Overview of water quality report findings

The report is dismissive of the risks to water quality in the reservoir, Riders Lane & Hermitage Streams, Langstone Harbour, and The Solent, without adequately considering all of the risks.

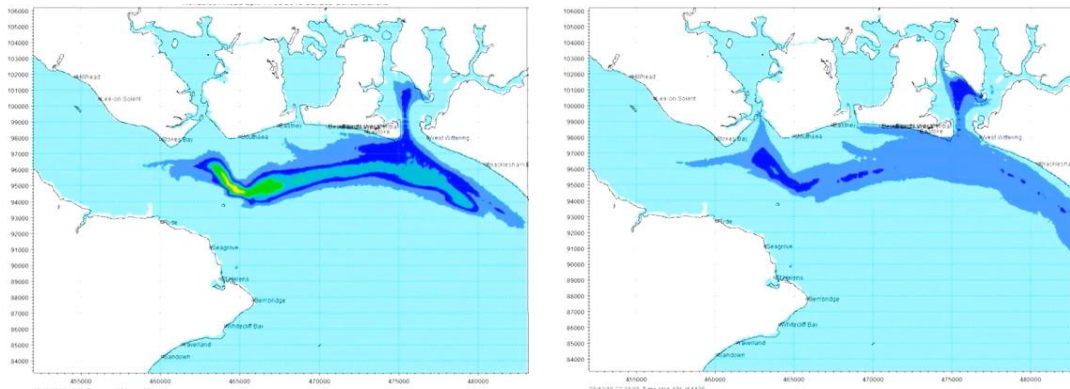
This confirms that the benefit of reduced nitrate flow into the harbour would be greatest when Bedhampton spring water is used to fill the reservoir post construction and after a drought drawdown event. If the effluent recycling plant is used as planned to add more water to the reservoir in a drought, then at the end of any drought event the reservoir water level is likely to be higher than it would have been without effluent recycling. This means that less spring water containing elevated nitrate will be needed to top up the reservoir after a drought and the nitrate benefit to the harbour from directing spring water to the reservoir will be reduced.

- This is a negative impact that has NOT been considered in the 2025 environmental water quality report.

The impact of the effluent recycling scheme in reducing this critical nitrate benefit to Langstone Harbour must be considered and properly reported.

Figure 3-13 Change in zinc concentration between the existing and future scenarios

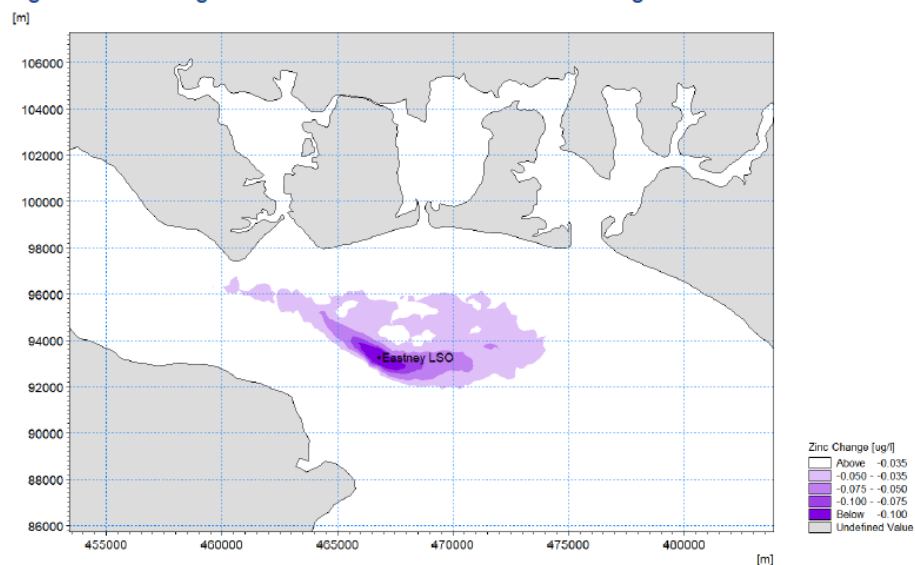
c) The timeframe over which the modelled outputs were generated is unclear. Previous modelling has shown that the LSO effluent plume can disperse across a very wide area of the Solent over a 72-hour period (see maps below and in Appendix A), where the plume dispersal changes over a number of tidal cycles. The length of the plume illustrated on the outputs on page 38 to 44 would suggest that modelling is over a very short timeframe, and therefore does not illustrate the full extent of the plume. The maps below show that it is critical that the modelling takes place over a minimum 72-hour period in order to assess the full extent of the impacts of the discharge of the reject water from the effluent recycling process.

d) The report indicates that they modelled the extent of the dispersion for the existing effluent discharge and the future (post effluent recycling) discharge, but these maps are not provided. As a result it is not possible to assess and peer review the model outputs. On pages 38 to 44 Southern Water only provide the modelled 'change'. For each parameter they should have provided the modelled dispersal plume for the existing LSO discharge, the future discharge including the more concentrated reject water and the 'change', to provide transparency and the opportunity for peer review against previous studies. The figures should reflect the model outputs for a spring and neap tide over a number of tidal cycles.

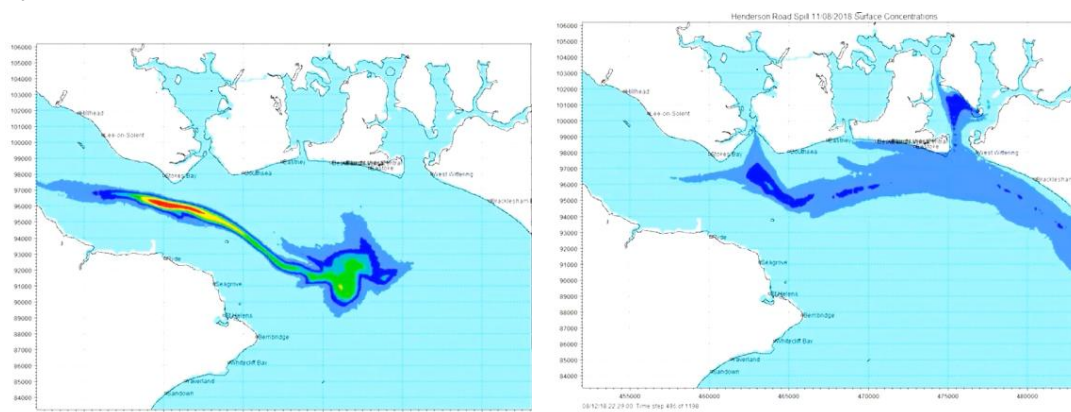
For comparison below are extracts from modelling outputs from the existing LSO outfall showing the plume extent over a much broader area, when considered over a multiple tidal cycles.
